Re: Newmar Corporation – Motor Vehicle Recall Notification

Subject: Recall Campaign No.: 08V-443

TSB 355

Subject: Missing heat shielding for engine exhaust.

Figure 1: No heat shield installed

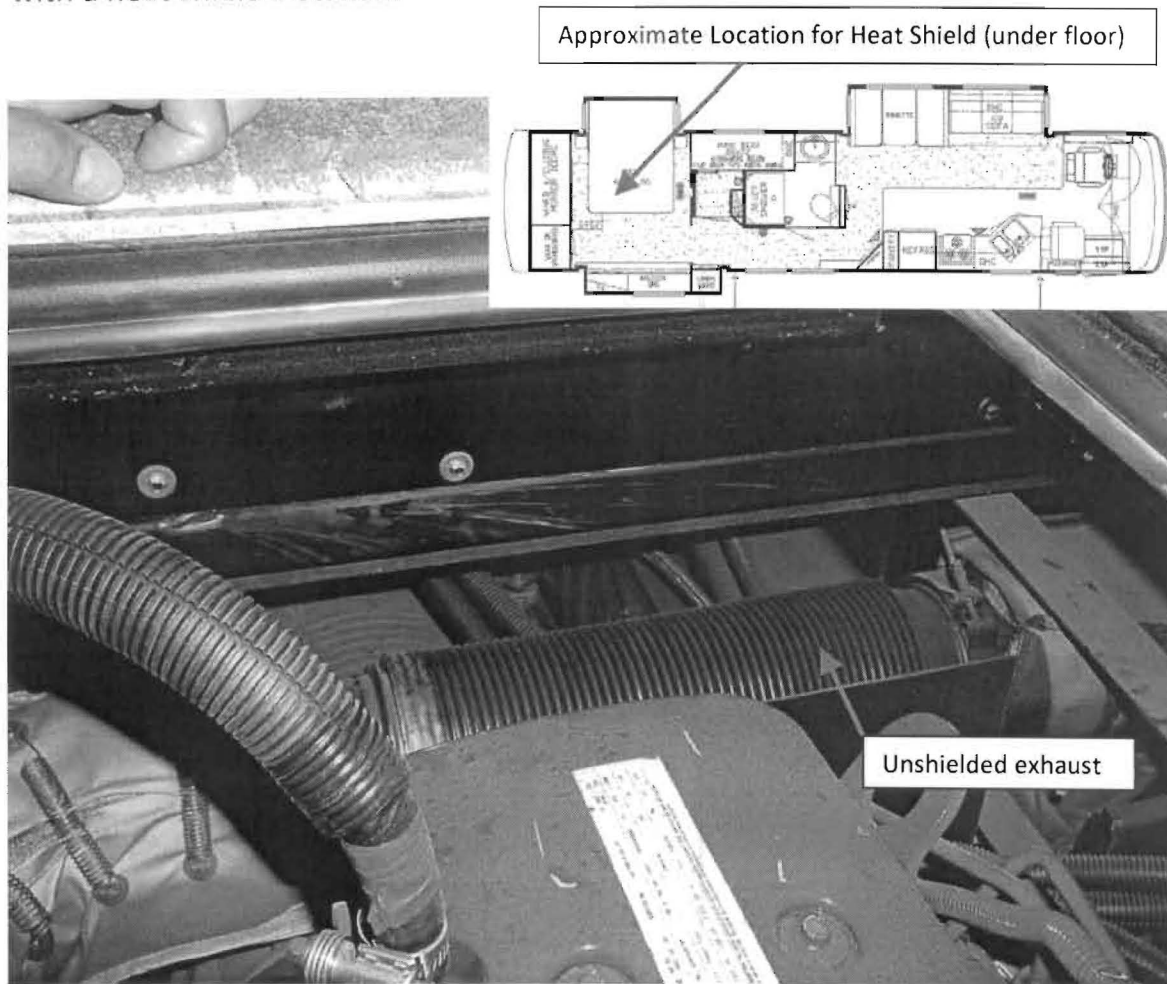
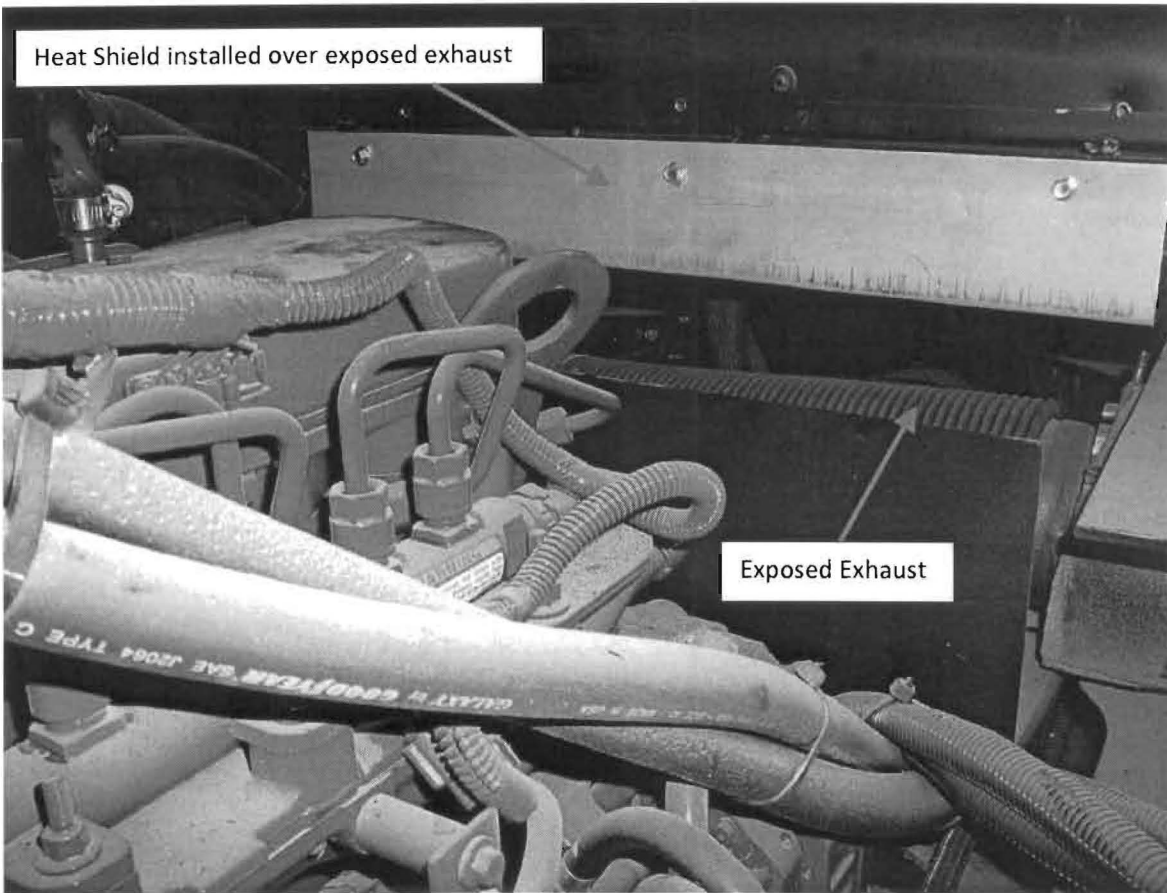
Condition: The polyethylene moisture barrier on the underside of the main floor above the engine compartment is unshielded from the primary engine exhaust. This lack of shielding and the proximity of the exhaust to the polyethylene moisture barrier may cause a thermal breakdown of the material, presenting a latent fire hazard.

Diagnosis Procedure: Move any obstructions, and open the engine access located in the floor. Look forward toward the front end of the engine compartment. Look for the heat shield on the cross member that is located just below the engine access opening. This heat shield will be installed on the cross member. Figure 1 shows the unit without a heat shield, figure 2 shows the unit with a heat shield installed.

If a heat shield is already installed, no further action is required.

If a heat shield is not present you will need to install one to redirect the heat. Use **ONLY** the specified Heat Shield (Newmar part #112234) for this recall.

Figure 2A

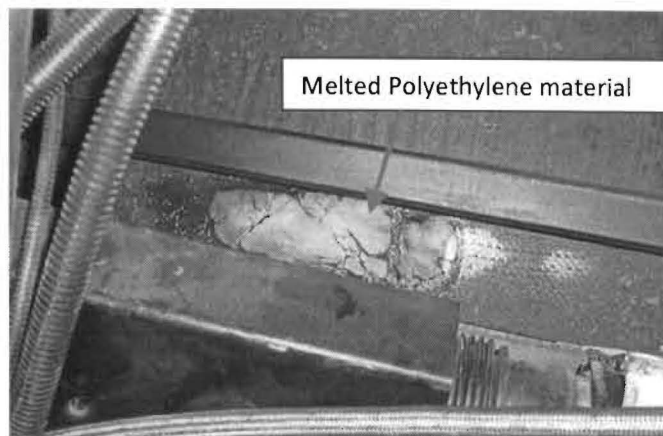
Before installing the heat shield, inspect the polyethylene vapor barrier above the exhaust for signs of heat damage. If the vapor barrier has been heat damaged, it will need to be repaired prior to installing the heat shield (see figure 2A).

If a repair is required, Newmar recommends installing a piece of .030 aluminum or galvanized steel, cut to fit, and secured into place with screws and silicone as necessary. This patch may need to be 17-33 in. by 3-4 in. and must be fastened directly to the stringers between the structural cross-members forward of the engine compartment. Clean any dust, dirt, or road debris from the area to be repaired, then install the cover into place over the damaged section. Inspect the repair to be sure it is thoroughly covering the damaged area, and is properly secured to insure it will not fall off.

Figure 3

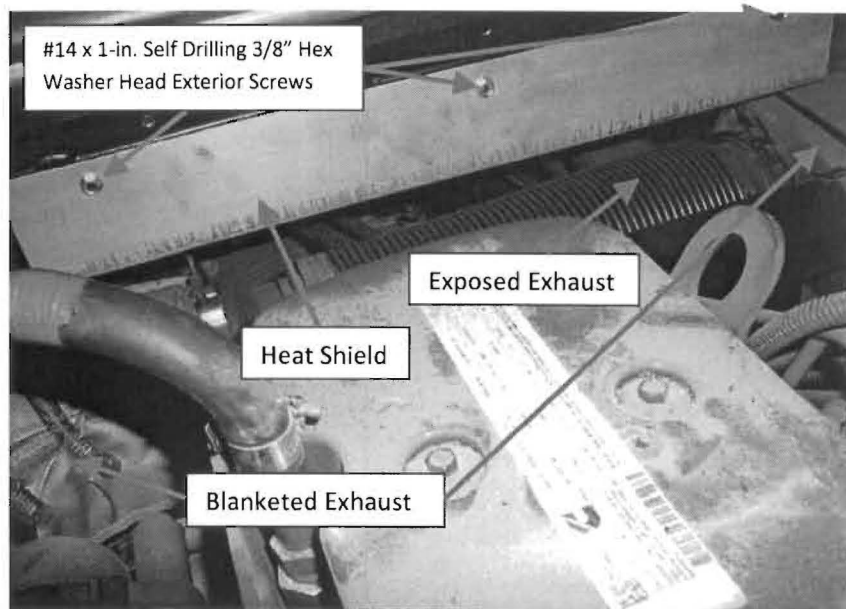
Position the heat shield over the exposed exhaust and fasten it into place using three #14 x 1-in. Self-Drilling 3/8" Hex Washer Head Exterior Screws. Position the heat shield so as to cover the entire exposed area of the engine exhaust (Figure 3).

It is important to make sure the heat shield is properly positioned to insure it covers the area of exposed exhaust. The exhaust on either side of the exposed section is blanketed and does not require shielding.

Figure 4: Check for contact / chaffing

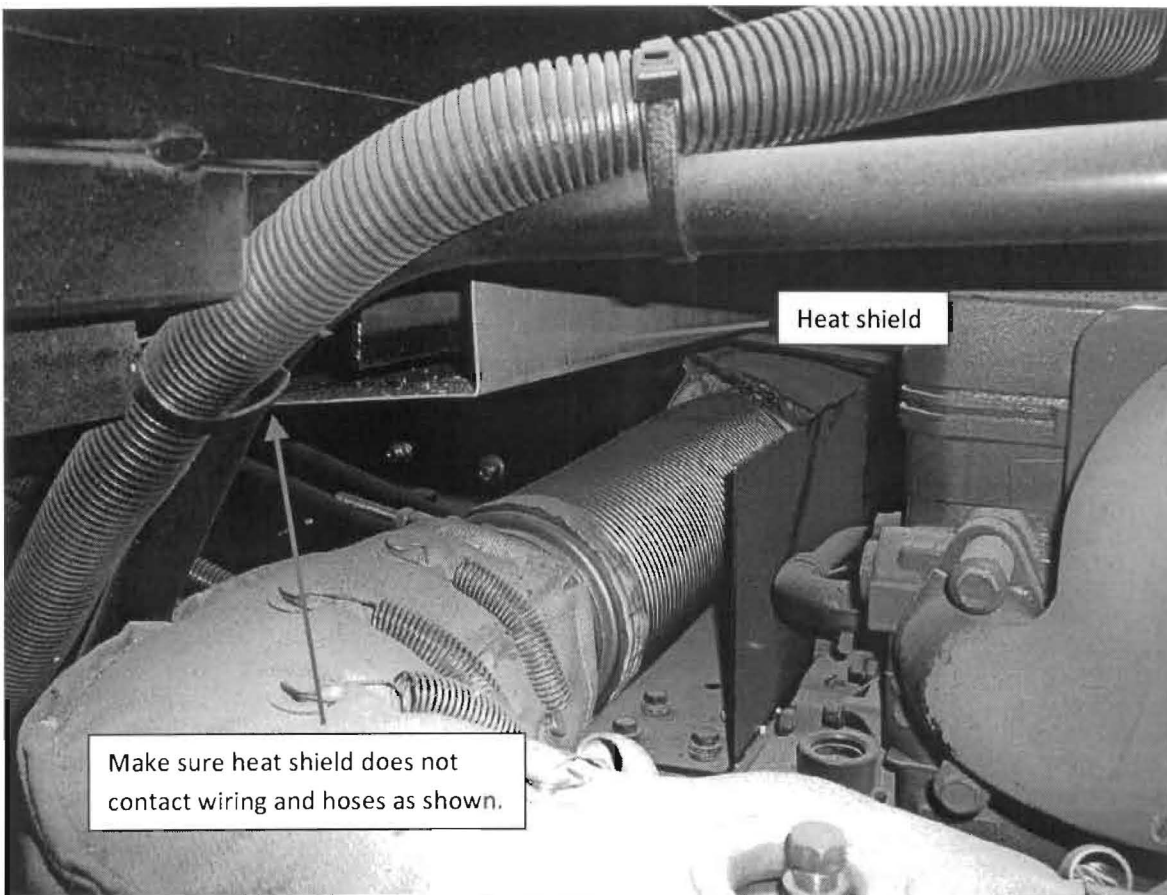
IMPORTANT: Once installed, be certain the heat shield is not rubbing against or chaffing any surrounding wiring, hoses, or other items in the engine compartment (Figure 4). Contact with wiring, hoses, and other items will cause excessive wear and potential failures in those components. If the heat shield is properly positioned (over the exposed exhaust between the two existing heat blankets) and there is physical contact between the shield and any wiring or hoses in the engine compartment, reposition the wires or hoses and tie them back to prevent chaffing. Positioning the heat shield properly between the heat blankets and over the exposed exhaust is critical to this repair.
